Subject: Virgil C. Summer Nuclear Station
Docket No. 50/395
Cold Overpressure Protection

South Carolina Electric and Gas Company (SCE&G) herein responds to the request by your staff regarding pressurizer PORV variable setpoints and adherence to 10 CFR 50 Appendix G limits, by providing a mark-up of FSAR Section 5.2.2.5. These changes will be incorporated into Amendment 31 to the FSAR.

5.2.2.5 RCS Pressure Control During Low Temperature Operation

Figure 5.2-15

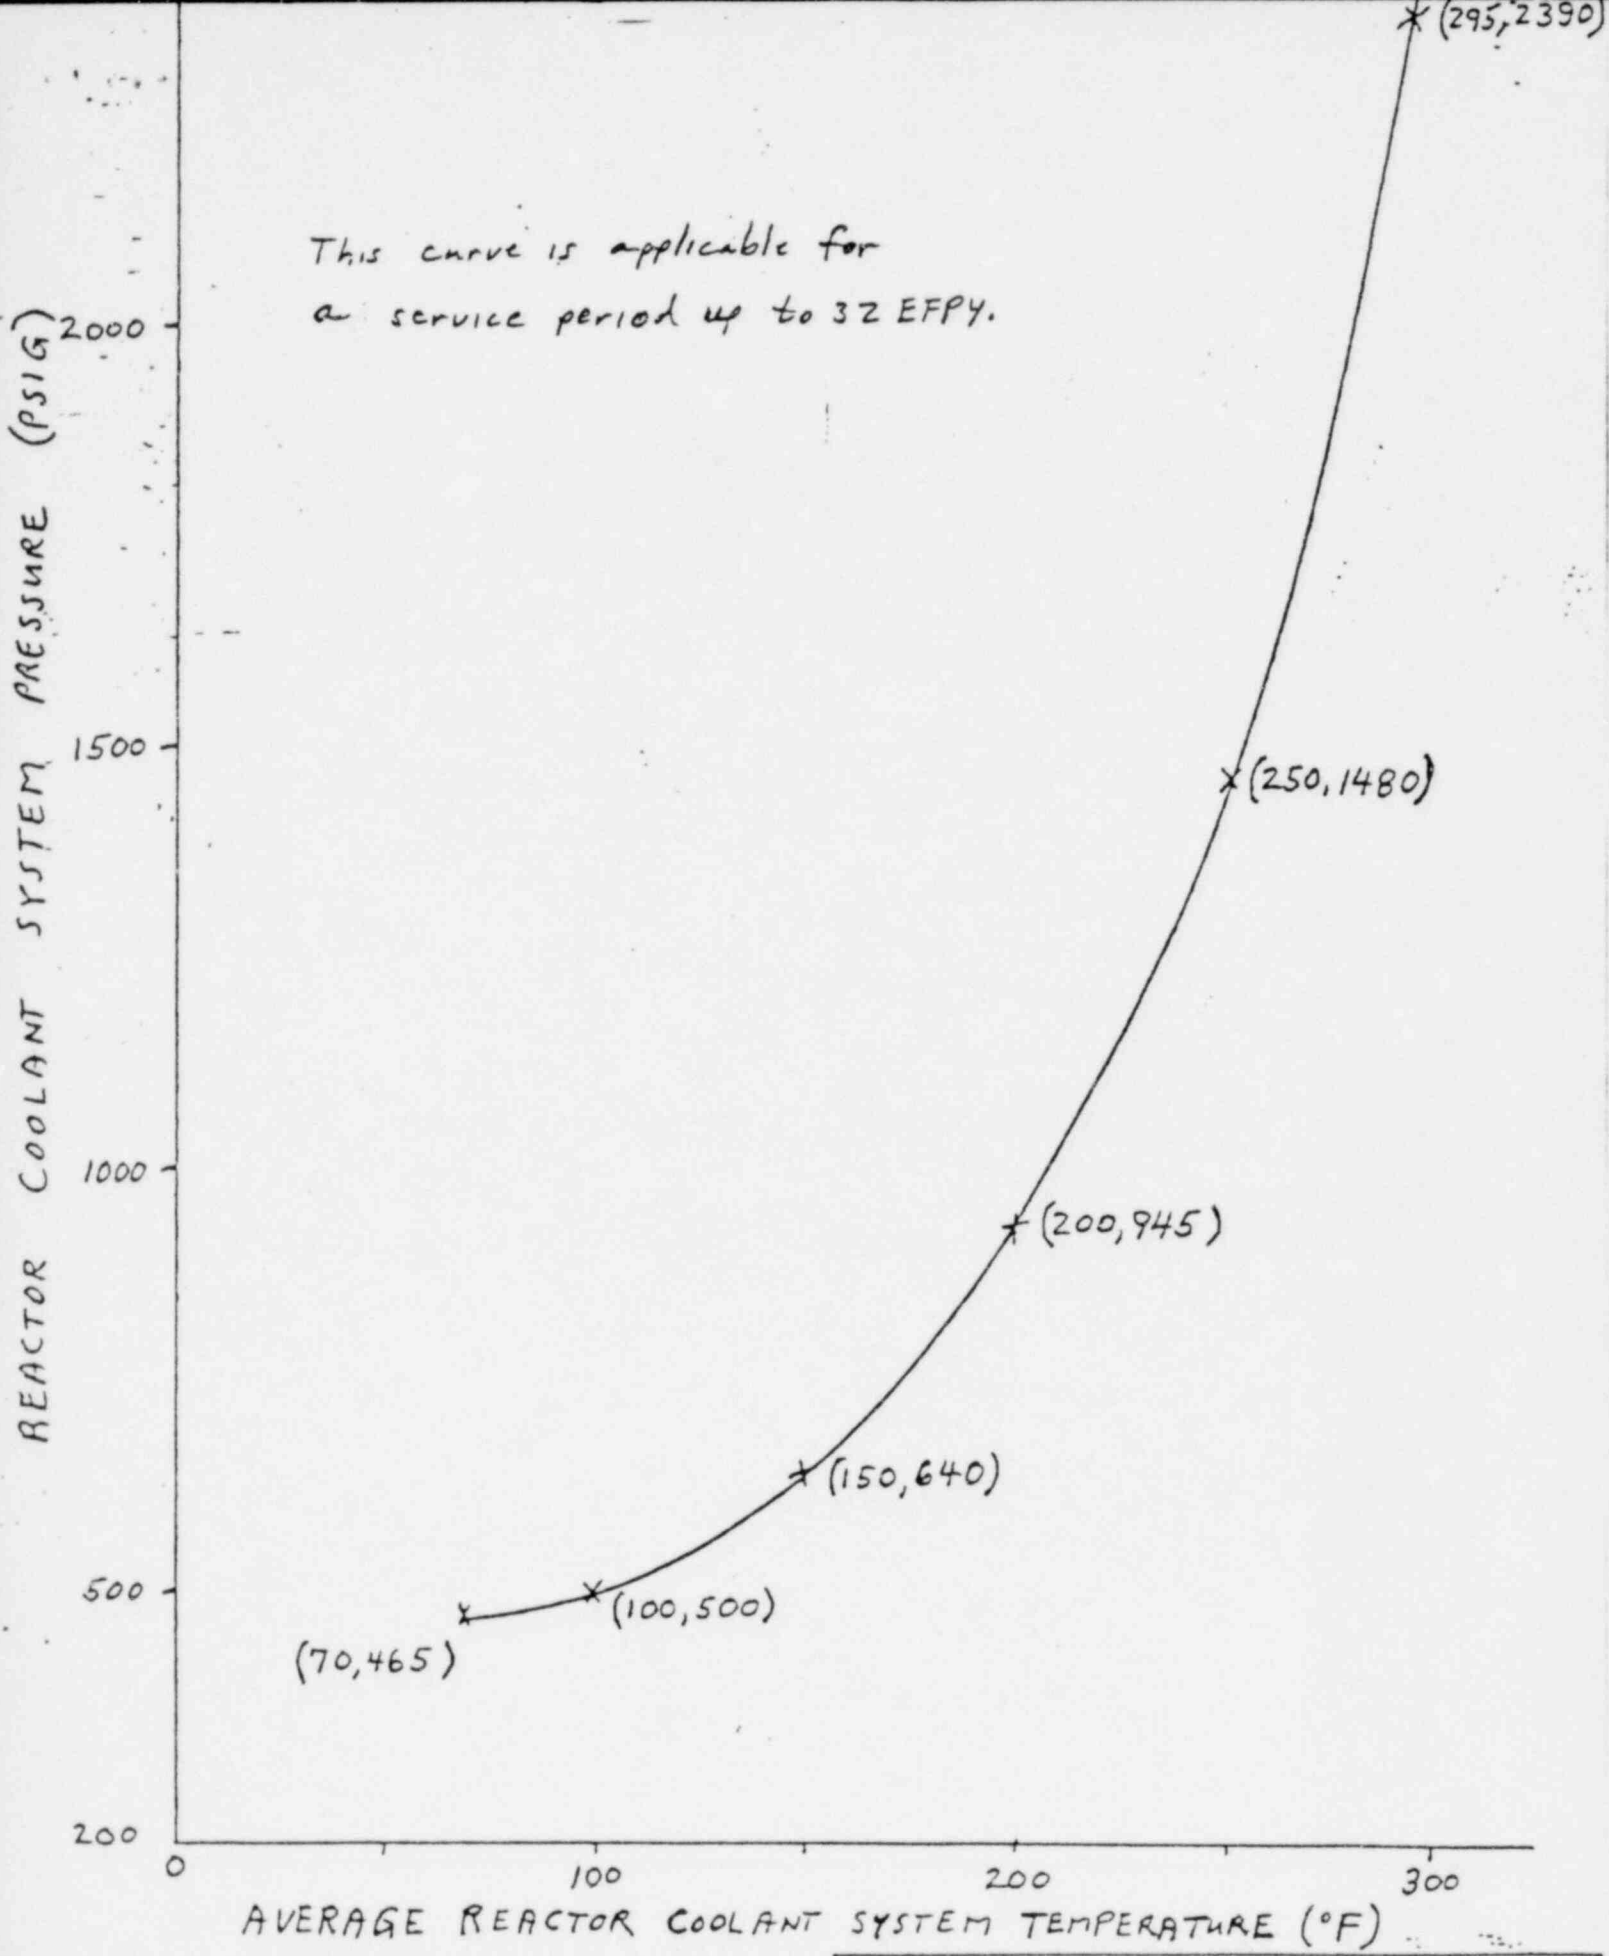
The OMS utilizes the PORVs with setpoints that vary depending on the average reactor coolant system temperature (T_{avg}). The lift settings are less than or equal to maximum setpoints defined by Figure 5.2-15.

Transient analyses were performed to establish a PORV lift setpoint program for the Overpressur Mitigating System (OMS) to be applied during shutdown operation of the plant. This program maintains reactor coolant system pressure within acceptable limits following all credible overpressurization incidents occurring in the plant during low temperature, water solid operation.
